EQUIPMENT SERIES: 62S

BULLETIN NO. 1

EQUIPMENT TYPE: 62S-1 VHF CONVERTER

SUBJECT: IMPROVEMENT IN OPERATION OF ALC CIRCUIT

Figure 1. Partial Bottom View of 62S-1

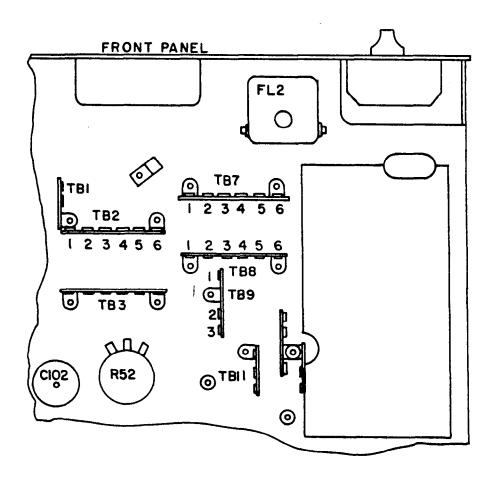
- 5. Place the unit upside down on the working surface with the panel closest to the operator. Refer to figure 1 for chassis layout and figure 2 for schematic diagram of modified circuit. (Reference also may be made to the 62S-1 Instruction Book, figure 6-2 for chassis layout.)

- 6. Locate terminal strips TB7, TB8, and TB9 above and slightly to the right of FL2. It is suggested in performing this modification, that all disconnecting and removal of components and wiring be done first, and then steps 7 through 16 gone over again to reconnect and install components and wires as specified. Grasp with a long-nosed pliers, or other suitable heat sink-device all diode leads to be connected or that are connected to terminals to which heat is applied.

- 7. Remove .1-uf disc ceramic capacitor C55, connected from TB7-2 to TB7-3.

- 8. Locate and remove the lead of 220-uhy choke L44, connected to TB8-3. Connect this lead to TB8-2
- 9. Locate and remove the lead of 1K, 1/2-watt resistor R21, connected to TB8-2. Connect this lead to TB9-1.

- 10. Locate and reve the leads of 18K, 1/2-watt resistor R59, connected from TB8-2 to TB9-1. Connect the leads of this resistor from TB8-3 to TB7-3.
- 11. Locate and remove the white-black-green wire from TB7-3. Connect this wire to TB7-4.

- 12. Locate and remove the green wire from TB8-3. Connect this wire to TB8-2.
- 13. Locate and remove the white-black-red-green wire from TB8-2. Connect this wire to TB9-1.

- 14. Connect 47K, 1/4 watt resistor R75 (745-0809-00) from TB8-2 to TB9-1.
- 15. Connect 1N457 diode CR10 (353-0204-00) from TB7-2 to TB7-3 with cathode (color bar) end connected to TB7-2.

- 16. Connect other 1N457 diode CR11 (353-0204-00) from TB8-2 to TB9-1 with cathode (color bar) end connected to TB9-1.
- 17. All solder connections should be made carefully, and all loose wire clippings and solder removed.

Figure 2. Schematic Diagram of Changes Resulting from this Modification

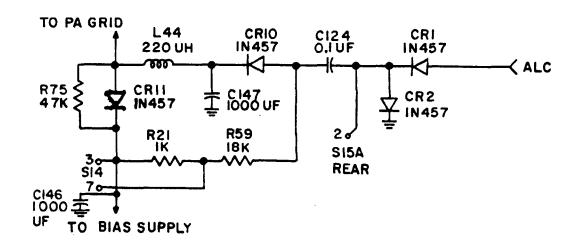
This modification will improve operation of the alc circuit. A 1N457 diode, CR10, is added to limit the operation of this circuit to changes in grid current of the proper polarity only. An additional 1N457 diode, CR11, and 47K resistor, R75, are added to increase efficiency of operation by providing a low impedance path between the PA grid and bias supply.
